**DELEGATED DECISION REPORT**

<b>Application Reference Number</b>	21NP0028LBC
<b>Description / Site Address</b>	Listed Building Consent - Internal and external works to accommodate extension of property into attached stables and change of use of attached outbuilding to provide self-contained unit of ancillary residential accommodation. Rebuilding of existing porch. Internal remodelling including relocation of stair. Replacement of modern window and patio door with windows to match existing at Threestoneburn, Powburn, Alnwick Northumberland NE66 4JN
<b>Expiry date of publicity / consultations</b>	18 May 2021
<b>Last date for decision</b>	21 June 2021 (Extension agreed to 19 <sup>th</sup> August 2021)

**Figure 2:** Existing (above) and proposed (below) south elevation

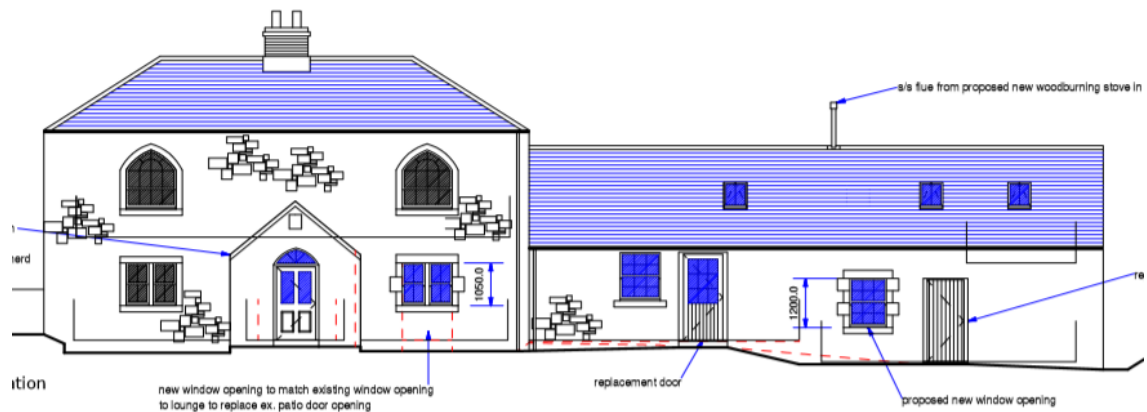
As the proposals relate to a Grade II Listed Building, the NCC Historic Buildings Advisor has been consulted on the proposals. Having considered the proposals as a whole, the Advisor has noted that the proposals are acceptable and will achieve a significant improvement in the current condition of the building and will help to enhance its significance as an important heritage asset. In addition to the above overview of the works, The Advisor has considered each of the various elements proposed in detail and has commented as follows:

Figure 4: Existing (above) and proposed (below) ground floor plan

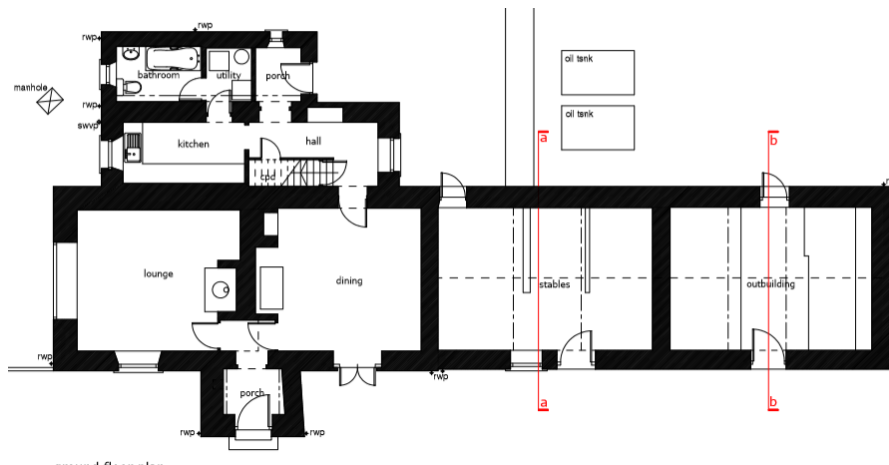
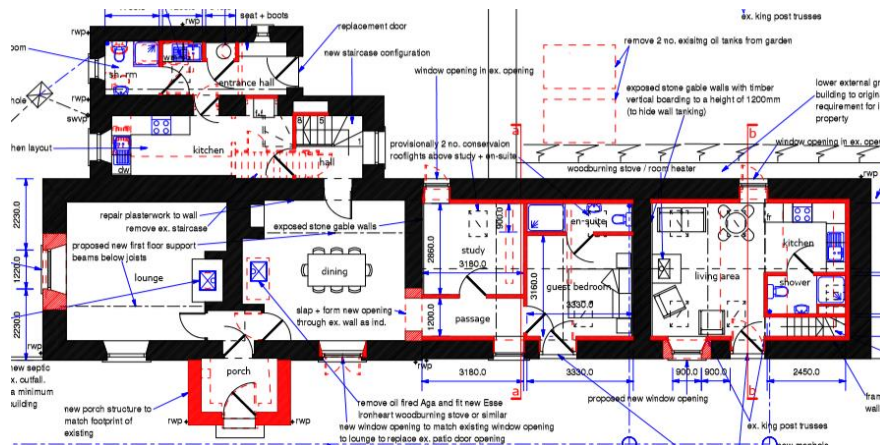
The Advisor has raised no objection to this element of the scheme, noting that the porch is a later addition to the main house. A condition has however been requested to ensure that the mortar used for the rebuilding of the porch is an NHL 3.5 Lime Mortar.

3. The mortar to be used in the rebuilding of the porch should be a Natural Hydraulic Lime (NHL) 3.5 Lime mortar only.
